Our Ref.: 12599404-Poulos-35

Southwest Excavation Area – Shoreline Design Deliverable
San Jacinto Waste Pits Superfund Site - Southern Impoundment, Harris County, Texas
Unilateral Administrative Order for Remedial Action of the Southern Impoundment
USEPA Region 6, Docket No. 06-05-21 (UAO)

**Revised Southwest Excavation Area
Shoreline Drawings**

C-46

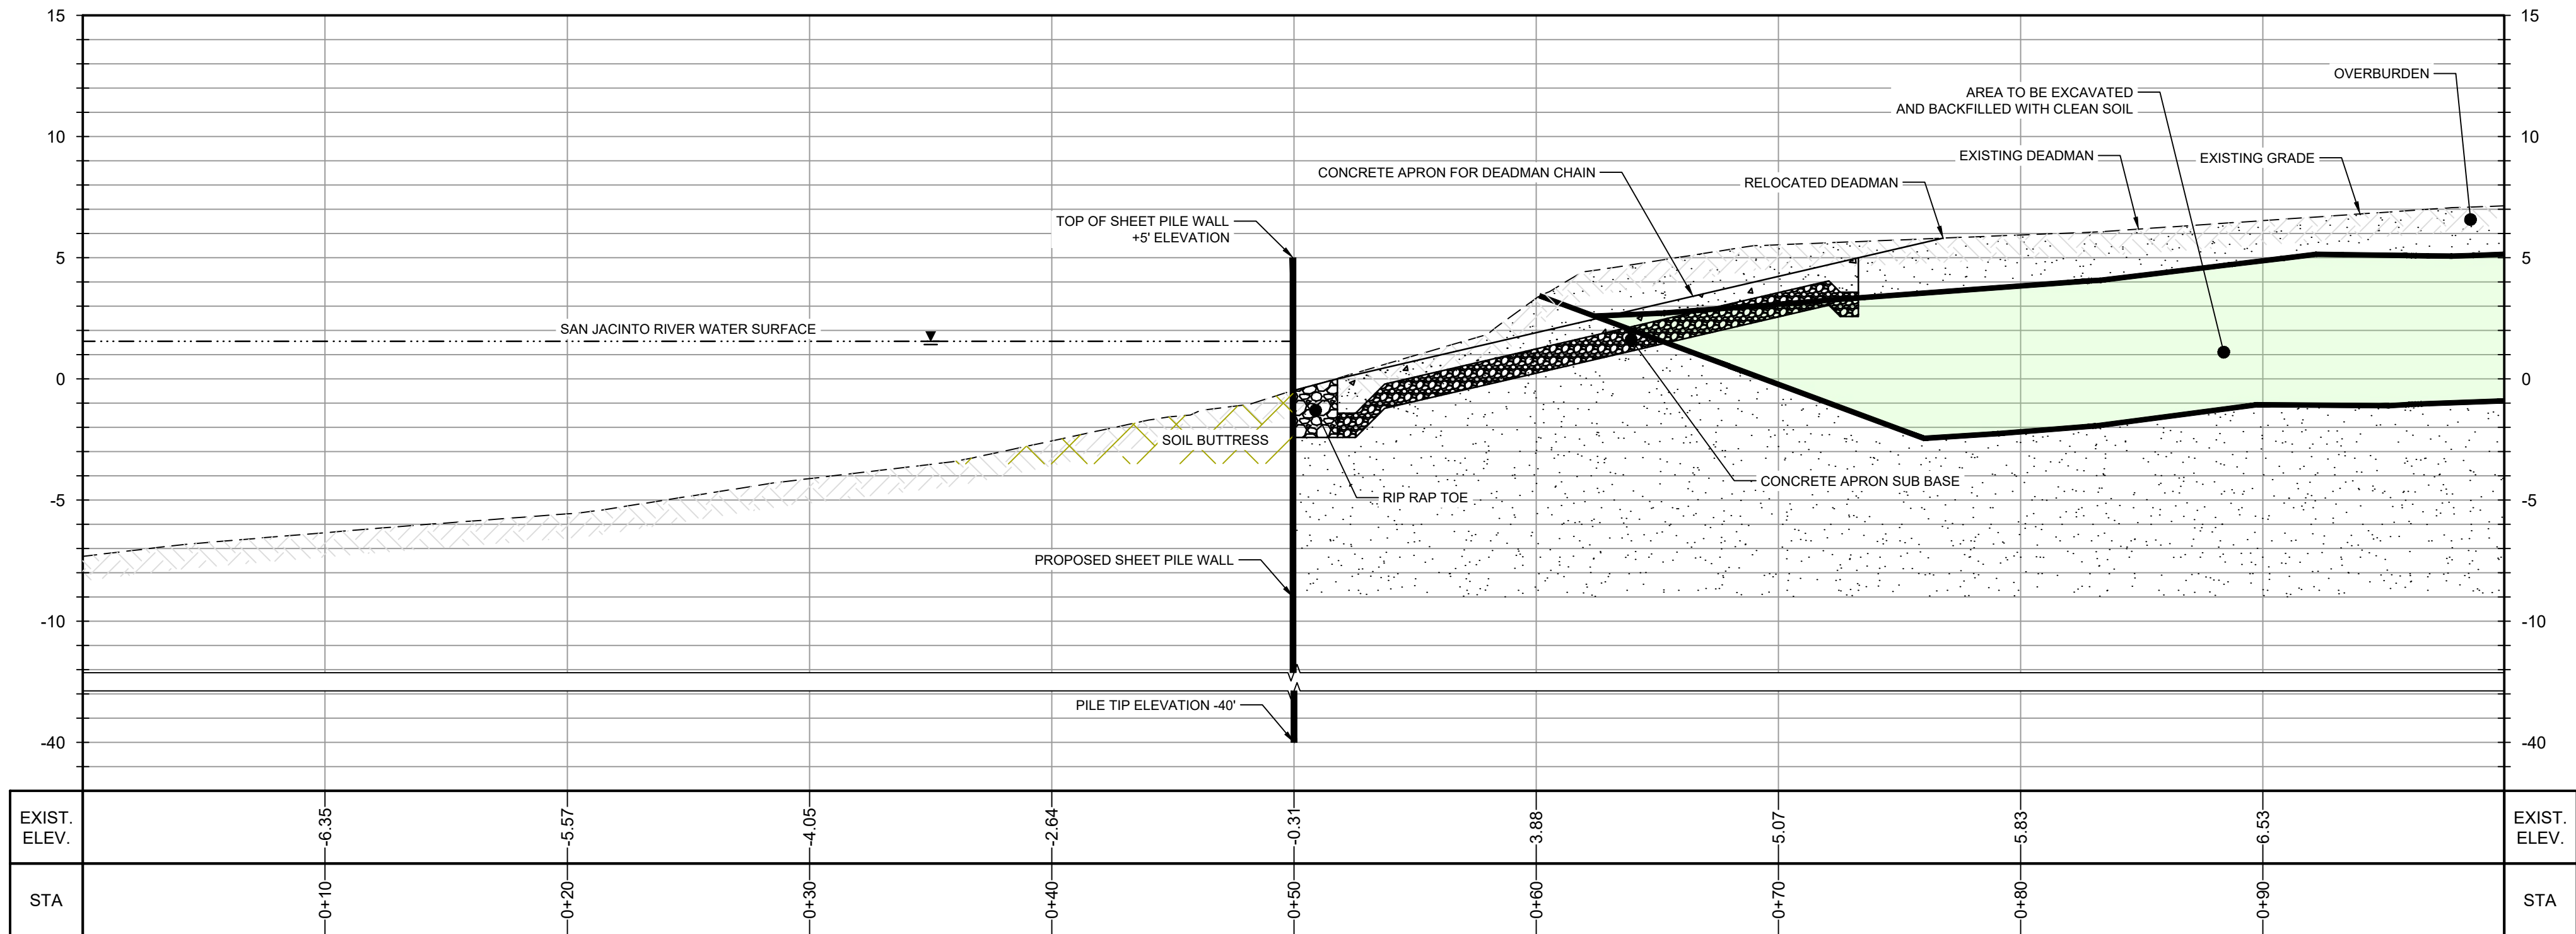
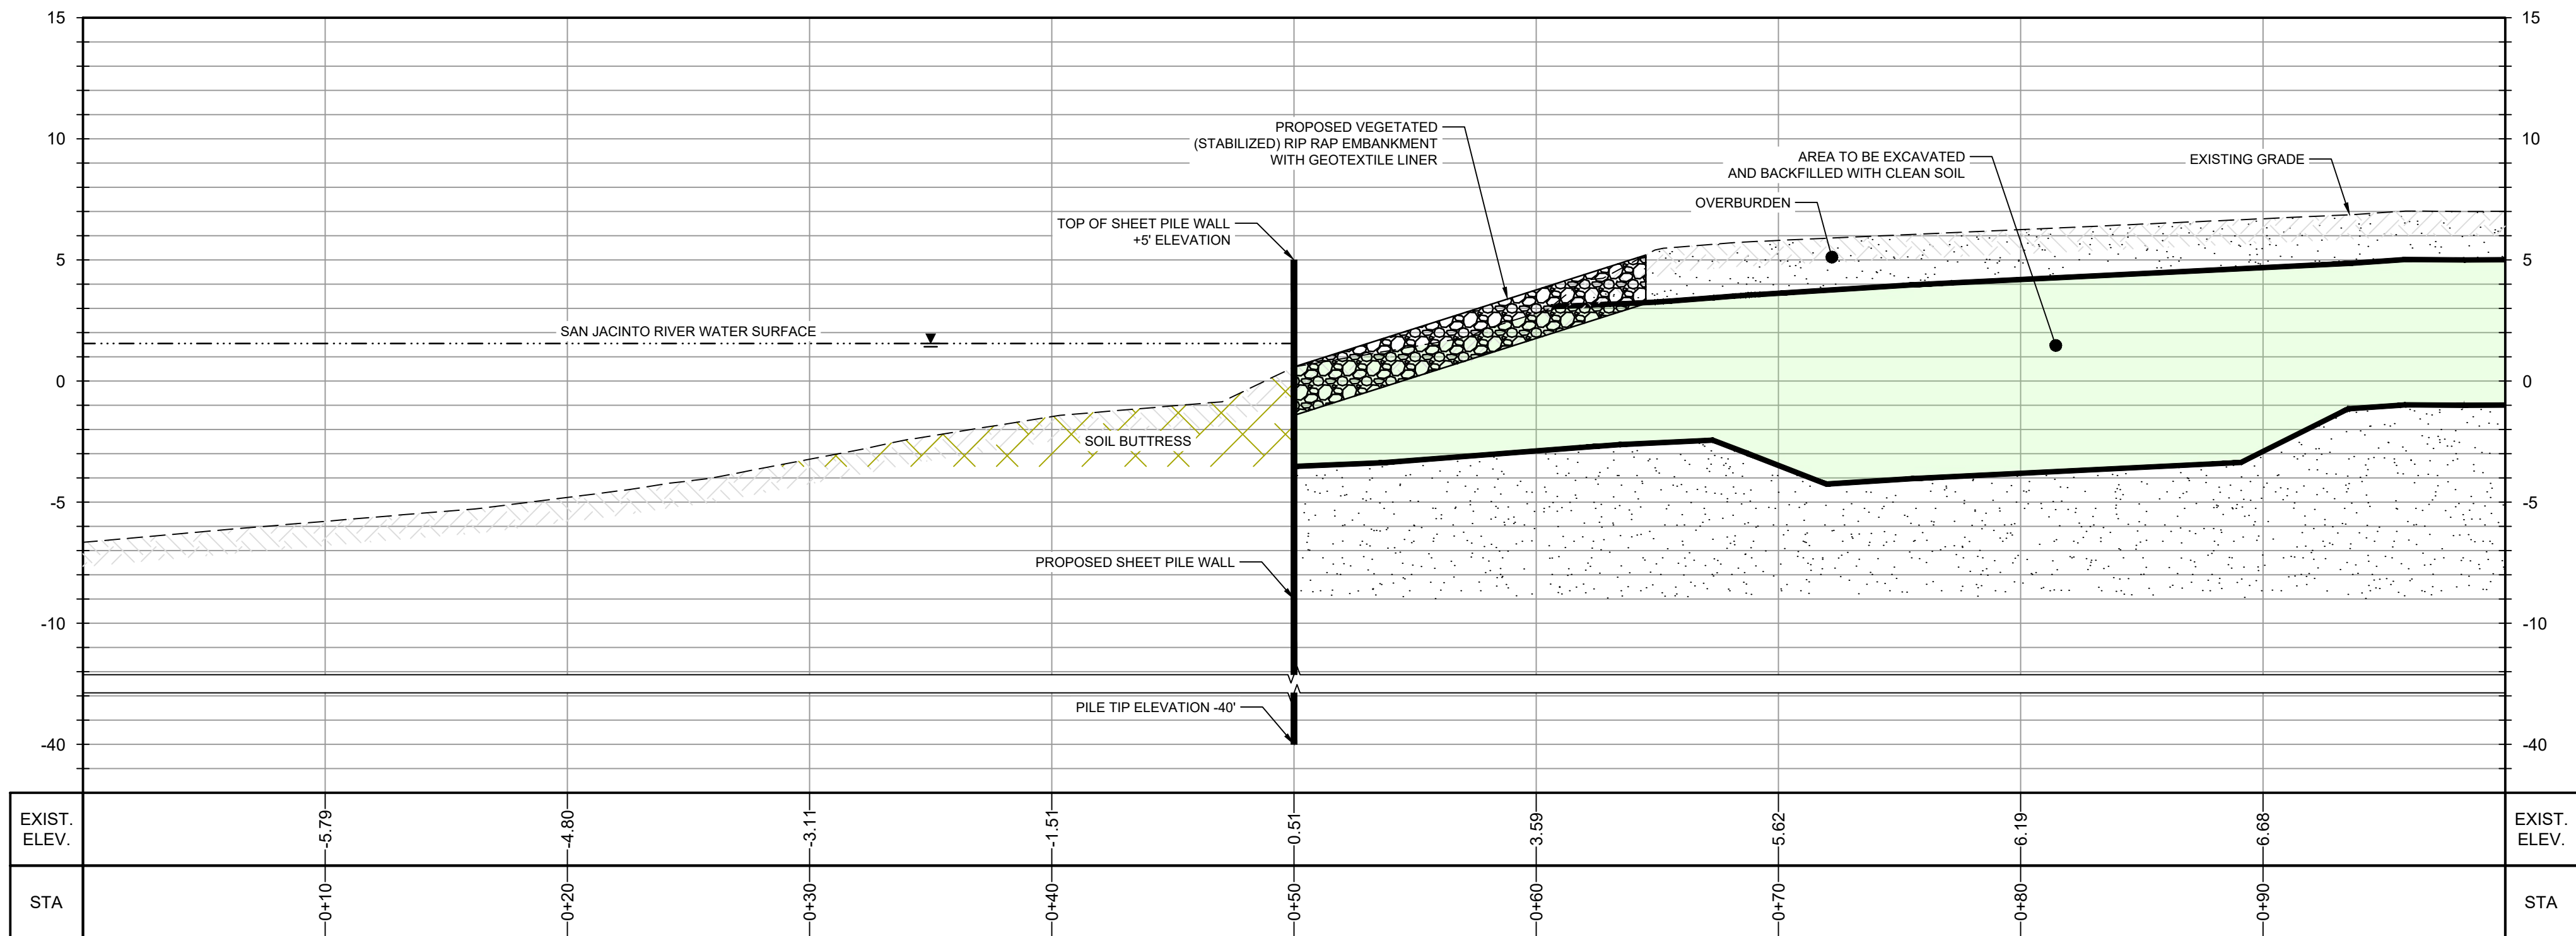
- "... the agency has determined that additional stabilization measures are needed along the southwest shoreline of the Southern Impoundment to ensure the remedy remains protective of human health into the long term. The bank slope that remains once the bulkhead is removed is steep in some areas."
- "If the bulkhead is removed, EPA recommends that rip rap and a strong vegetative cap be utilized for additional erosion control and bank stabilization along the shoreline in the area of the bulkhead to improve erosion protection after it is removed."

- “EPA expects components in the bank stabilization design would include but are not limited to: keying the structure at a proper angle into a toe below water line to support the weight of the rip rap; layered stabilization approaches potentially with geotextile to contain fine particle sized soil materials; and the use of silt fencing or other erosion-control measures while native vegetation establishes on the riverbank slope.”

- A rip-rap embankment will be constructed as part of backfilling and site restoration across the length of the Southwest Excavation Area that requires soil removal to the toe-of-slope.
- The placed backfill will be graded at approximately 3:1 slope and covered by geotextile, and approximately 24 inches of rip rap. Soil will be placed within the rip rap void spaces to allow vegetation to re-establish.
- The top of the rip rap slope will be seeded with grasses to provide further vegetation stabilized top of slope.

GHD prepared six cross sections at various locations perpendicular to the sheet pile wall, as shown on Drawings C-46, C-47, and C-48 (also in Attachment 1). The cross sections show excavation of impacted soil and placement of clean backfill as specified in the remedial design. The revised shoreline drawings incorporate the bank stability components of the design and replaces Drawing C-41 included in the 100% RD Addendum.
